OHIO TURNPIKE AND
INFRASTRUCTURE COMMISSION

ADDENDUM NO. 1

PROJECT NO. 39-16-01 (PART A)
RIGHT TWO (2) LANES AND SHOULDER RECONSTRUCTION
MILEPOST 107.3 TO MILEPOST 112.5
ERIE COUNTY, OHIO

PROJECT NO. 39-16-01 (PART B)
BRIDGE DECK REPAIR & REHABILITATION
OHIO TURNPIKE OVER NS RAILROAD AND KELLY ROAD MILEPOST 117.3
OHIO TURNPIKE OVER US ROUTE 250 MILEPOST 118.1
ERIE COUNTY, OHIO

ABUTMENT PLAN

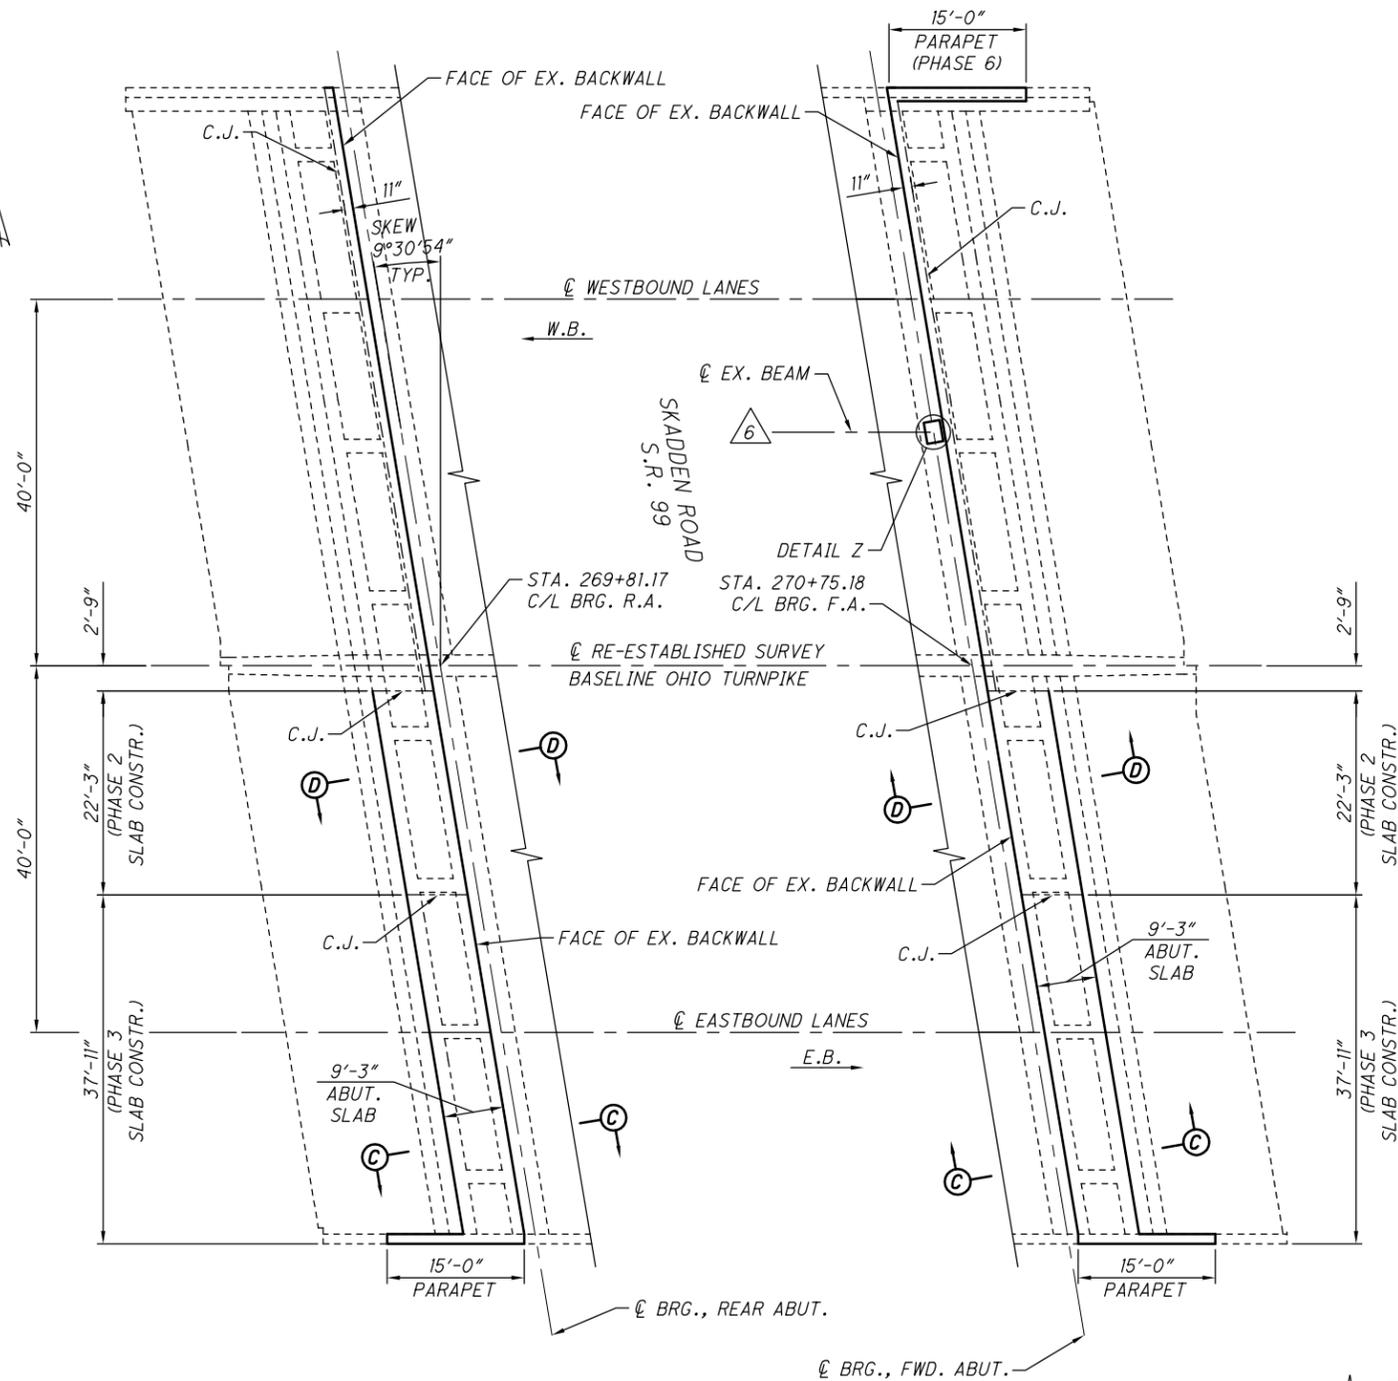
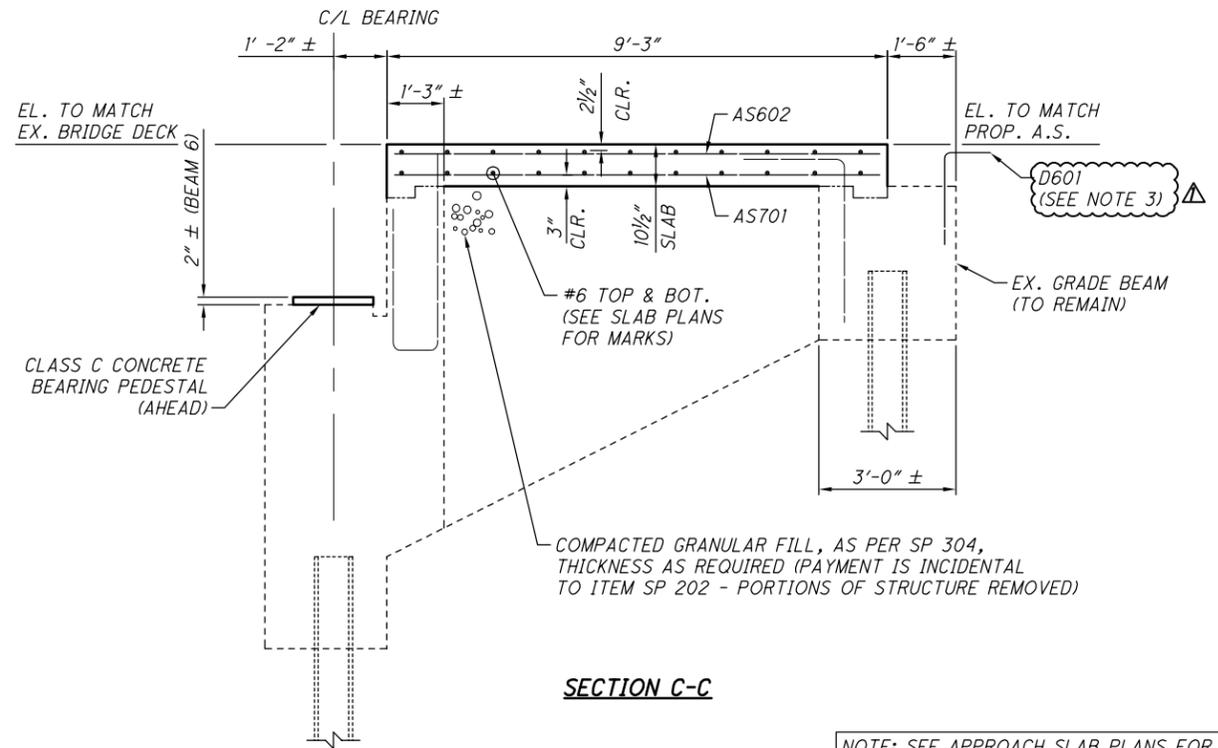
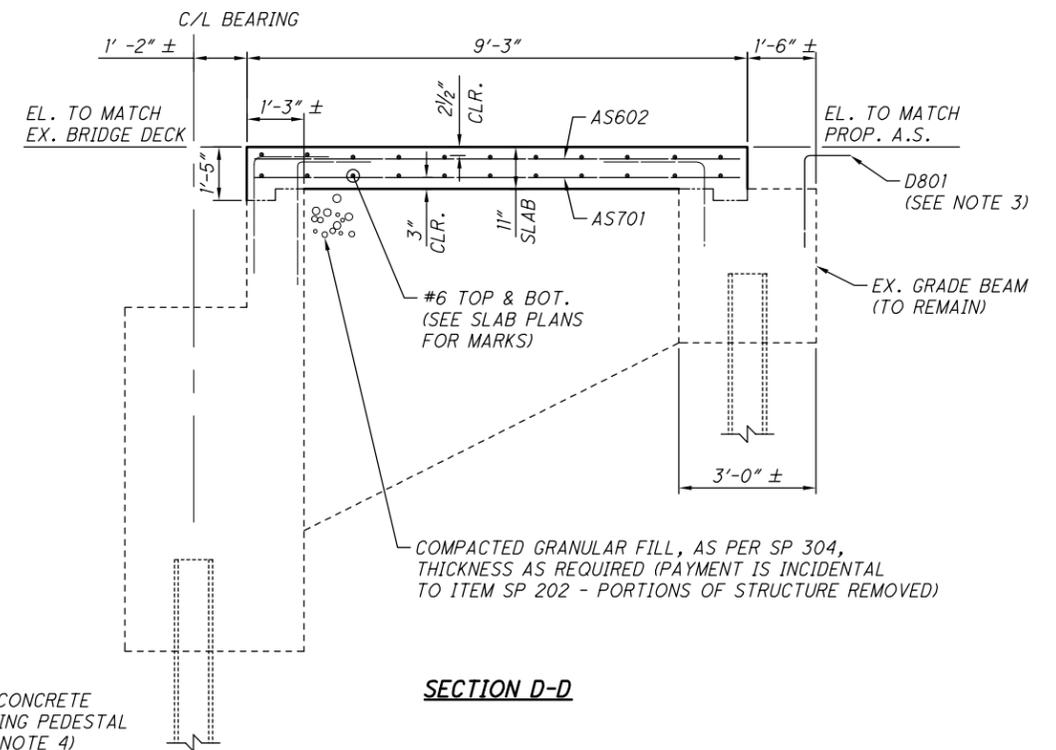
Q#3 Sheets 405,411,417,425 call for D801 Approach Dowels Per Note 3. Is the intent of this bar to replace the #6 bars called out on OTIC SD AS-5 Note 5? Please define spacing of D801 bars and #6 bars to be installed. Also, please clarify how the doweling of the D801 bars are to be paid.

A#3 Through this Addendum No.1, the specifications for D801 bars are deleted and replaced with D601 bars and the spacing of these D601 bars to agree with OTIC Standard Drawing AS-5. Plan notes and Plan callouts have been modified on Sheets 375 through 384 of 432 and Sheets 405, 406, 407, 409, 411, 412, 413, 415, 417, 418, 419, 420, 421, 423, 425, 426, 427 and 431 of 432 to substitute D601 for D801 bars. The cost of the dowel holes and D601 bars are incidental to SP526 – Approach Slab, As Per Plan therefore quantities for Item 510 – Dowel Holes with Non-shrink, Non-Metallic Grout and SP 509 – Epoxy Coated Reinforcing Steel, As Per Plan have been reduced on Sheets 391 through 394 of 432.

- FOR ABUTMENT SLAB REMOVAL DETAILS, SEE SHEET 1 OF 8.
- FOR REINFORCING BAR PLACEMENT DETAILS, SEE SHEETS 3 & 4 OF 8.
- INSTALL D601 APPROACH SLAB DOWELS PER C&MS 510. PLACE DOWEL WITH NON-SHRINK, NON-METALLIC GROUT. DRILL DOWEL HOLES 4" (MIN.) CLEAR OF GRADE BEAM'S EDGE AND 12" DEEP. DOWEL HOLES COST IS INCIDENTAL TO THE COST OF SP 526 - APPROACH SLAB. D601 COST IS INCLUDED UNDER SP 509 - EPOXY COATED REINFORCING STEEL, AS PER PLAN.
- PAYMENT FOR REPLACING CONCRETE BEARING PEDESTALS IS UNDER ITEM 511 - CONCRETE MISC.: REPLACE EXISTING CONCRETE BEARING PEDESTAL. SEE ITEM 511 GENERAL NOTE FOR ADDITIONAL INFORMATION.

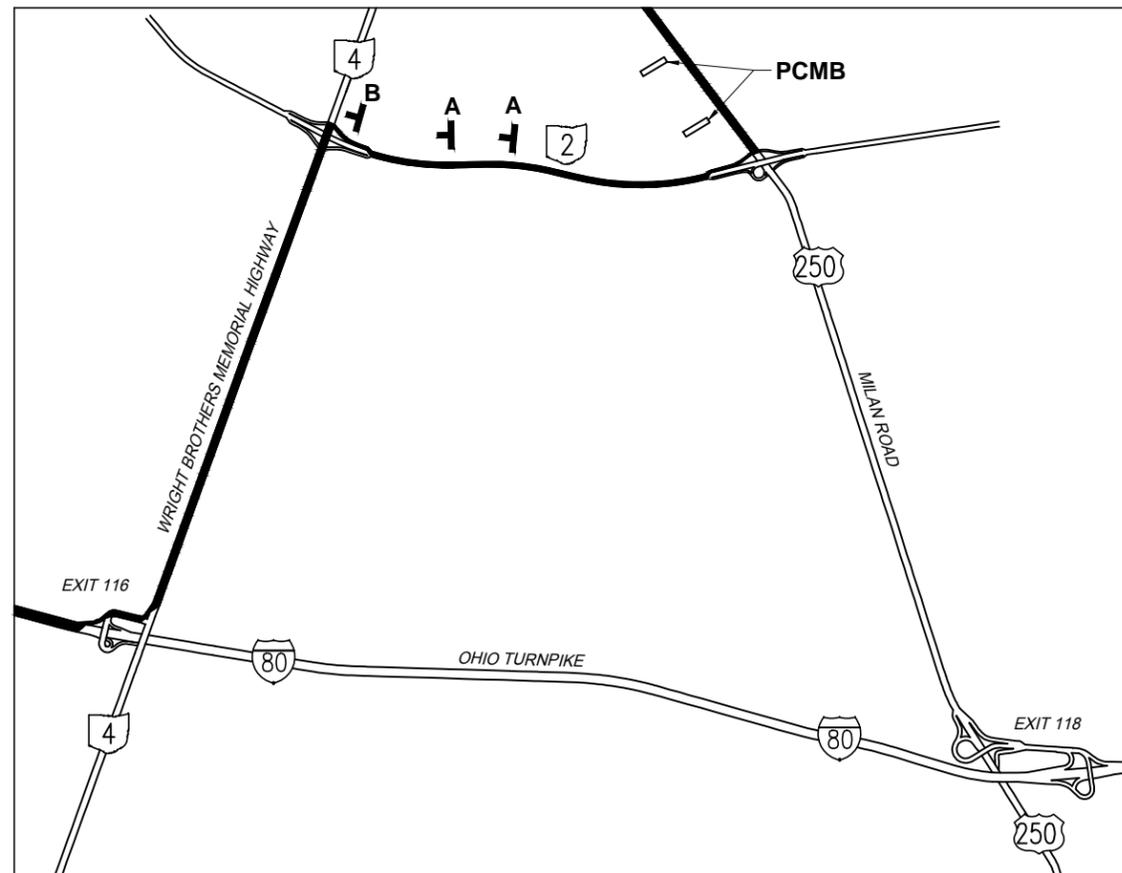
Q#13 PART B SHEET 7/24, Last paragraph defines the restrictions on overlay placement and requires the placement to be on a Friday night. Will the contractor be required to take a lane closures before, during, or after the placement of an overlay?

A#13 *Traffic shall be placed in a single lane during and at least 12 hours after the deck pour. The speed limit shall be reduced to 35 MPH through the single lane section. During EB deck pours, PCMBs shall be relocated to notify traffic of possible delays. During WB deck pours, there will be additional traffic control needed on US 250 SB and SR 2 WB in Perkins Township. This Addendum No. 1 adds a PCMB location map and notes to Plan Sheet 7 of 24.*

WHEN PERFORMING ANY WESTBOUND (WB) BRIDGE DECK OVERLAY LOCATE TWO PCMBs ALONG US 250 SOUTHBOUND (SB) PRIOR TO SR 2. THE TWO PCMBs PLACED ALONG US 250 SB WILL BE USED TO NOTIFY MOTORISTS OF POSSIBLE DELAYS. THE PCMBs SHALL BE IN ADDITION TO THE FOUR PCMBs BEING USED ALONG THE TURNPIKE MAINLINE.

THE FIRST PCMB SHALL BE PLACED APPROXIMATELY 6,000 FEET NORTH OF THE SR 2 WESTBOUND ENTRANCE RAMP. THE SECOND PCMB SHALL BE PLACED APPROXIMATELY 1,000 FEET NORTH OF THE SR 2 WESTBOUND ENTRANCE RAMP.
